# Recall Bulletin

**SUBJECT:** Lapbelt Pretensioner Locking Performance

**MODELS:** 2013 Buick Encore  
2013 Cadillac ATS 4-Door  
2013 Chevrolet Trax  
and  
Vehicles that were serviced with a suspect part:  
2013-2014 Buick Encore  
2013-2014 Cadillac ATS 4-Door  
2014 Cadillac CTS Sedan (VIN A)

GM Recall #14171

3966508

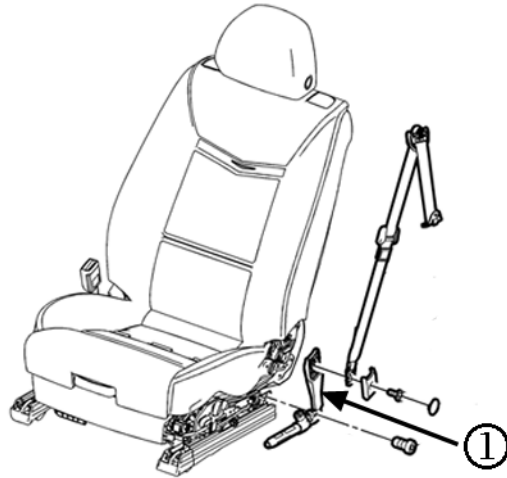
Dealers are to replace both front outboard lap belt pretensioners.

1. Remove the driver and passenger seat belt tensioner assemblies (1). Refer to *Front Seat Belt Anchor Plate Tensioner Replacement* in SI.
2. Install new driver and passenger seat belt tensioner assemblies. Refer to *Front Seat Belt Anchor Plate Tensioner Replacement* in SI.
